Site Address: 2709 21ST AV SAC St: Unit #2

Nature of Work: NSFR WITH DETACHED GARAGE

TRUSS REPAIR

Job: (raw0229) Eiden Grow / A2-REPAIR

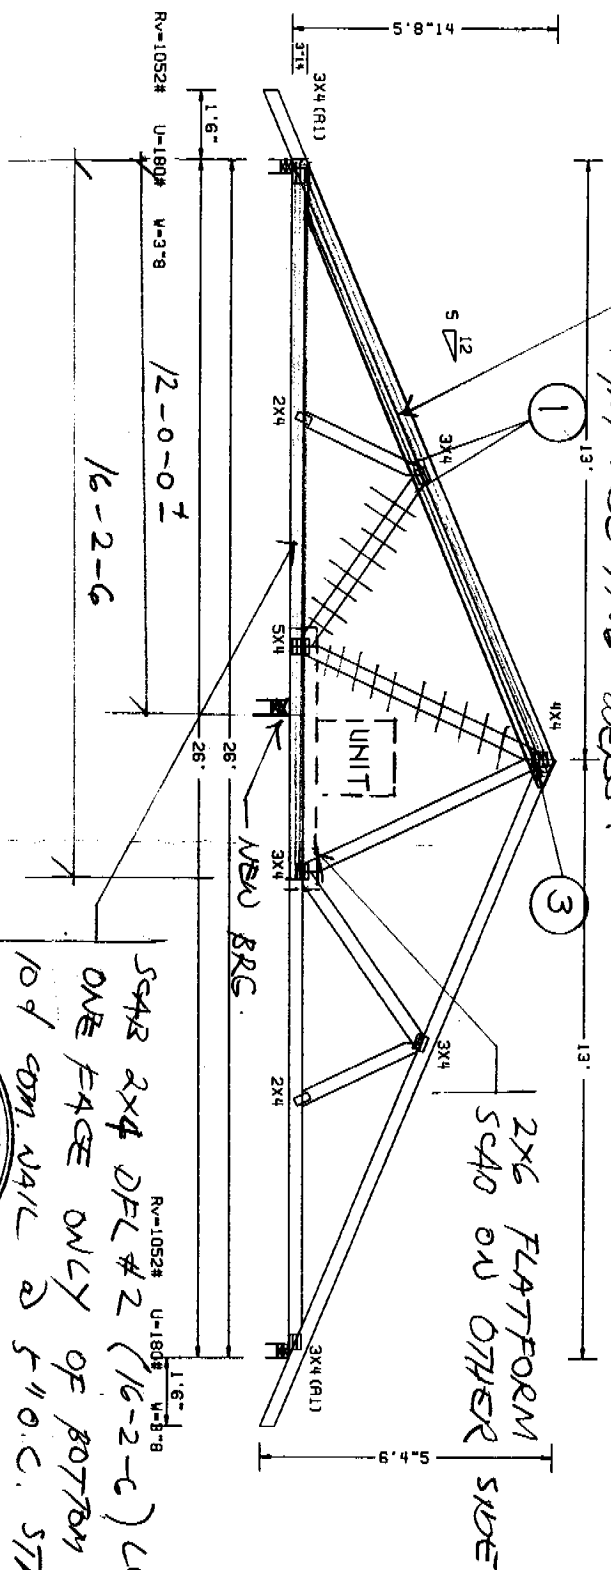
PROBLEM: NEED TO CUT and REMOVE WEBS
 AS SHOWN FOR HVAC and ATTIC ACCESS.

REPAIR: AS SHOWN

SCAB 2x6 DFL #2 TO TOP CH. ON BOTH FACES
 w/ 10d COM. NAIL @ 4' OC. STAGGERED ALONG
 TOP CH + EXTRA NAIL AS ENDSIDE TO EACH
 10' EXPOSURE WEBS.

2x6 PLATFORM
 SCAB ON OTHER
 SIDE

SCAB 2x4 DFL #2 (16-2-c) CONS TO
 ONE FACE ONLY OF BOTTOM CH w/
 10d COM NAIL @ 5' O.C. STAGGERED

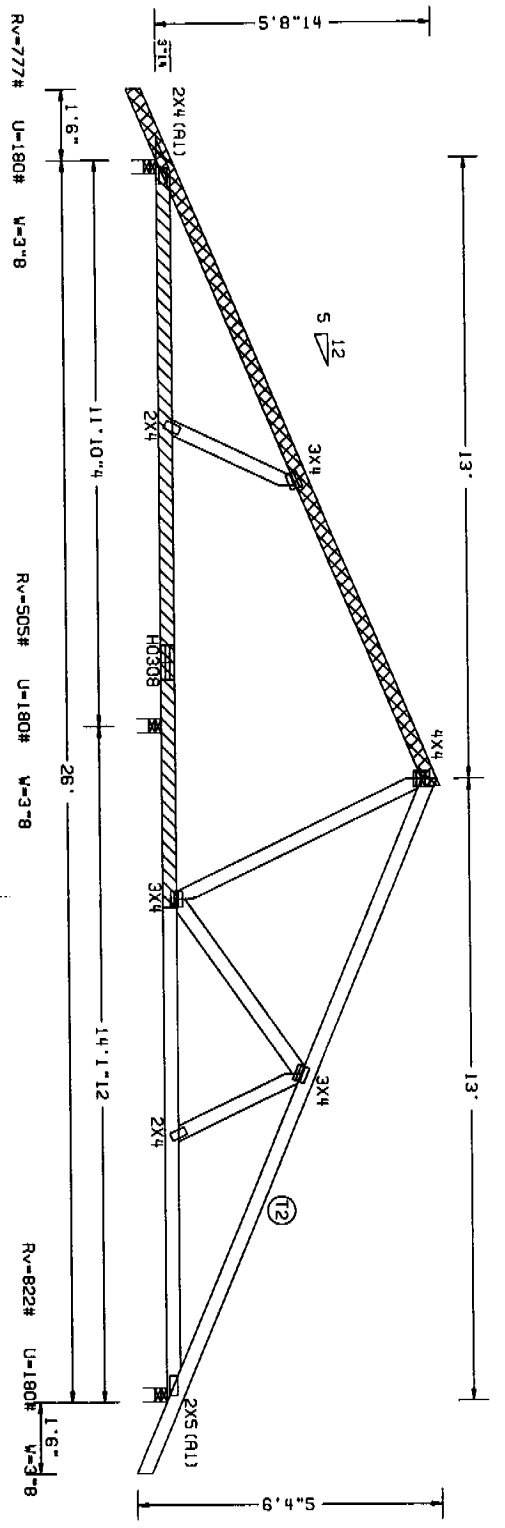
Re-run for Repair

(1) 2x4x16-1-2 DF-L #2(g) BOTTOM CHORD SCRS CENTERED 7'-7" FROM LEFT END. ATTACH TO ONE FACE OF CHORD WITH (2) ROWS OF 0.131"x3" Gun-alls @ 6" O.C., STRAGGERED 3".

THIS DWG. PREPARED BY THE ALPINE JOB DESIGNER PROGRAM FROM TRUSS MER'S LAYOUT
 80 MPH WIND.
 CALCULATED HORIZONTAL DEFLECTION IS 0.33" DUE TO LIVE LOAD AND 0.42" DUE TO DEAD LOAD.
 IN LIEU OF RIGID CEILING USE PURLINS: TO BRACE BC @ 120" OC
 ** WARNING! PANEL-POINT DEFLECTIONS EXCESSIVE ** TRUSS HAS VERTICAL DEFLECTION OF 0.63" DUE TO LIVE LOAD AT X = 5'-7"-6".
 (2) 2x4x16-0-0 DF-L #2(g) TOP CHORD SCRS CENTERED 5'-9"-15" FROM LEFT END. ATTACH ONE TO EACH OUTER FACE OF CHORD WITH (2) ROWS OF 0.131"x3" Gun-alls @ 12" O.C., STRAGGERED 6".
